SUBJECT: Police Headquarters WJE Clarification Letter – Phase 2 Peer Review Report – Life Safety Category

SUBJECT: New Police Headquarters — Phase 2 Peer Review

Findings of our structural design review of the FLPHQ building are summarized below. Only comments which warrant direct response from Thornton Tomasetti (TT), the Structural Engineer of Record (SEOR), are provided below. Items 1 through 8 are related to life safety and warrant attention either *as soon as possible* or in the near term. Suggested timeframes to complete rectifications are provided for each life-safety finding. Time frames are not provided for serviceability (Items 9 through 11) or documentation findings (Items 12 through 16), but we recommend that these items be resolved as soon as is practicable, but no later than within 12 months.

Figure 40. One potential location for the proposed new reinforced concrete shear wall

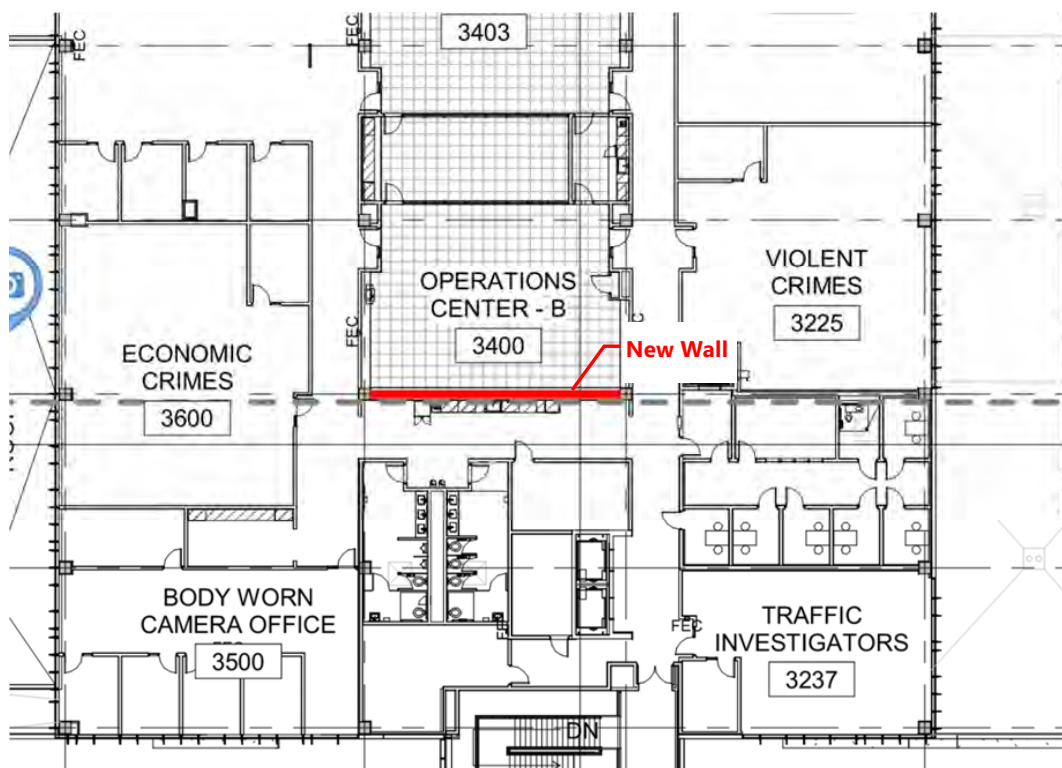
The addition of a shear wall at the location recommended in Figure 40 will not fully rectify the sliding deficiency of mat footing CF-1 (under the north stair shaft). One way of enhancing the sliding resistance of this footing is to connect or tie it to adjacent column spread footings, as illustrated in Figure 41. If CF-1 is connected to the column spread footings at Grid Points J/3, K/3, and K/4, the additional gravity load on these columns will provide additional frictional resistance against sliding resistance for the combined foundations. To connect the footings, new segments of reinforced concrete foundations can be cast. These new tie footings sections should have sufficient strength to transfer the lateral sliding loads from the mat footing and column spread footings. The new tie footings would also need to be reinforced to preclude other limit states such as (e.g.,) one-way shear.
